Contract #: 04-0120F4Cty: SF/ALA Rte: 80 PM: 13.2/13.9File #: 69.15**SOURCE INSPECTION REPORT****Resident Engineer:** Pursell, Gary**Address:** 333 Burma Road**City:** Oakland, CA 94607**Report No:** SIR-000743**Date Inspected:** 12-Jul-2009**Project Name:** SAS Superstructure**OSM Arrival Time:** 0**Prime Contractor:** American Bridge/Fluor Enterprises, a JV**OSM Departure Time:** 12**Contractor:** Zhenhua Port Machinery Company, Ltd (ZPMC), Changxing Island**Location:** Changxing Dao, Shanghai

Other: Surface Preparation and Coatings Application**Bridge No:** 34-0006**Component:** OBG CB4, Misc. Metal**Bid Item:** 77,78,79,80**Lot No:** B226**Summary of Items Observed:**

OBG Miscellaneous Metal

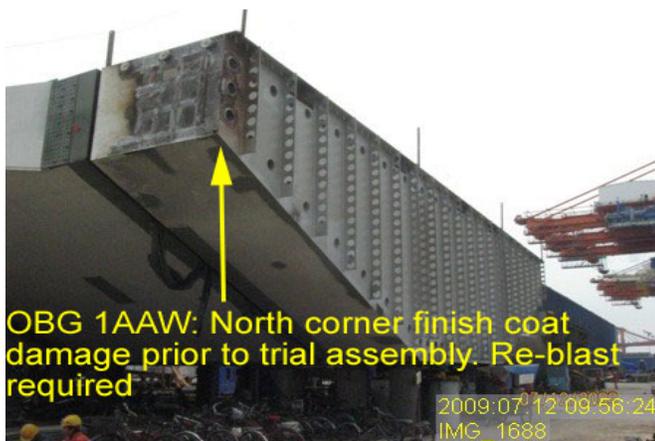
Caltrans QA Coatings Inspectors received Notices of Inspection to attend joint inspections with ABF and ZPMC QC for surface preparation by abrasive blasting and primer coat application on 12 channels. After looking at the abrasive blasted surfaces it was determined by ABF and CT that the base metal on several of the items did not

meet the Society for Protective Coatings (SSPC) SP10 Near White Metal Contract requirements. ZPMC was informed by ABF QC that further grinding and abrasive blasting was required. ABF QC's determination was verified by Caltrans QA Coatings Inspector Jordan. The contractor began performing the repairs as directed by ABF QC personnel. After the second inspection was completed the items that were determined to successfully meet the SSPC SP10 Near White Metal Contract requirements were transported to the paint shop area and spread out for primer application. Residual Chlorides (soluble salts) tests were performed on the abrasive blasted surfaces. Surface profile Testex Tape was used by ZPMC QC personnel to record the blast profile. The Testex tape was measured using a dial micrometer. The micrometer readings of the Testex Tape were within the contract requirements of 40 and 86 microns. Ambient conditions were within Contract required parameters. The surfaces to be coated were blown down again with compressed air to remove dust. After the dust was removed, Interzinc 22 primer was applied within the specified 8 hour window after the start of abrasive blasting. The coating was mixed under the supervision of International Paint's Onsite Technical Services Representative, QC personnel representing ABF and ZPMC.
